SUBJECT: COMANCHE PEAK STEAM ELECTRIC STATION (CPSES) - UNIT 2
DOCKET NO. 50-446
REQUEST FOR ADDITIONAL INFORMATION ON ME215,
SAPCAS COMPUTER CODE

4. GENX CALCULATION 544 - Reconciliation of Local Evaluation Using ME215 Analysis

PROJECT COMANCHE PEAK STEAM ELECTRIC STATION-UNIT 2 JOB NO. 20935
CALC. NO. 2-NP-GENX-544 REV. 0 PAGE 6
Subject: Reconciliation on Local Stress Evaluation Using ME215 Analysis

Logic For Reconciliation of ME215 Analyses

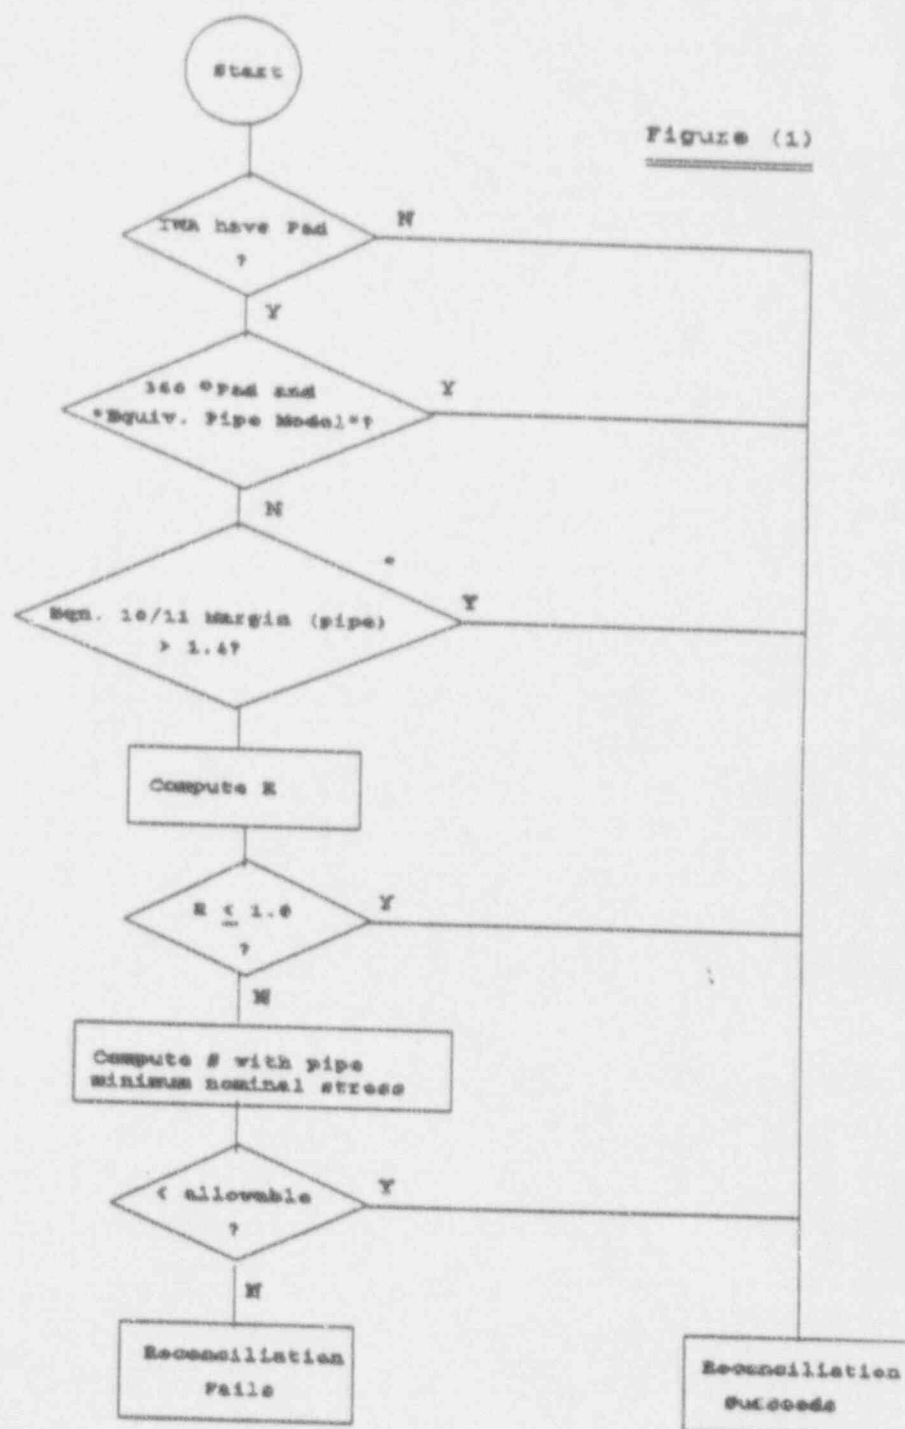
Figure (1) illustrates the reconciliation method described in GENX-544. Table (1) lists all of the pipe supports for which an ME215 analysis has been performed to qualify an integral attachment to the associated piping, identified to date. The first query of figure (1), "IWA had pad?" corresponds to the column titled "Pad?" in table (1); the second query of figure (1), "360° Pad and Equivalent Pipe Model?" corresponds to the next column to right in Table (1) (titled "360 deg. Pad + Eq. Pipe Mod."). The query "Eqn. 10/11 margin" conditional of figure (1) has been subdivided into two columns in table 1.

The reconciliation procedure described in GENX-544 provides that if no pad exists at the attachment, the ME215 analysis is reconciled for finite element mesh size without further evaluation (see figure [1]). Therefore, those problems with "N" (i.e., "no") in the column titled "Pad?" in table (1) pass the reconciliation without evaluation of any other attributes as listed in the columns to the right. Similarly with the other attributes, if the column with the below titles have the classification listed below the reconciliation passes without need to evaluate other attributes:

The results of the reconciliations are shown in the right-most column of table (1); a "P" indicates the ME215 analysis was reconciled for element size concerns, an "F" indicates the opposite.

GENERAL STRESS DECAY CURVE

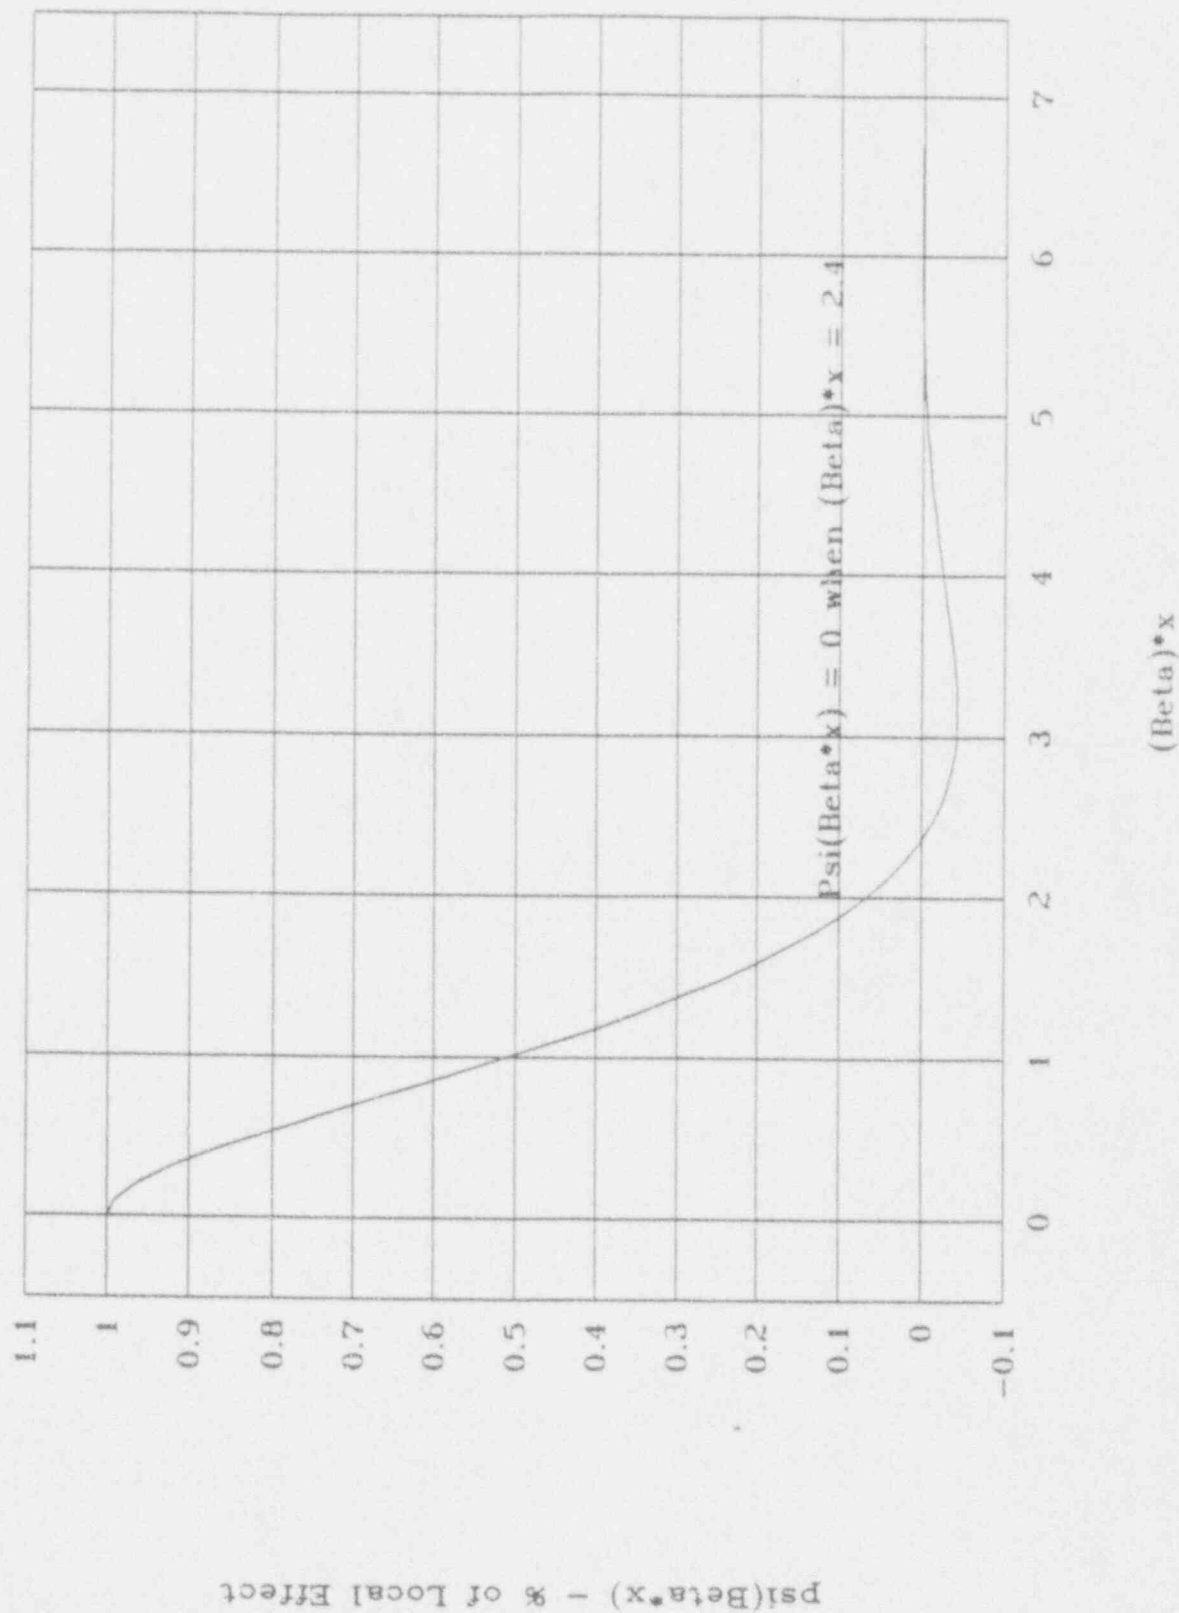
The ME215 automatically generated element sizes at the critical regions are selected based on the experiences of previous finite element analyses and the industry practice. The selected element size in these regions is approximately equal to the size of the element thickness. The element size at the critical area of the pipe is equal to the pipe wall thickness. Based on Timonsenko's "Theory on Plates and Shells", the local effect will decay within \sqrt{Rt} of the distance (this is supported by ASME Section III), if the size of finite element is less than $\frac{1}{2} \sqrt{Rt}$, it will pick up more than 90% of local effect. The element size equal to the pipe wall thickness is less than $\frac{1}{2} \sqrt{Rt}$ (as shown in the attached table). Therefore, the size of element used in ME215 is adequate and is sufficient to account for local effect.
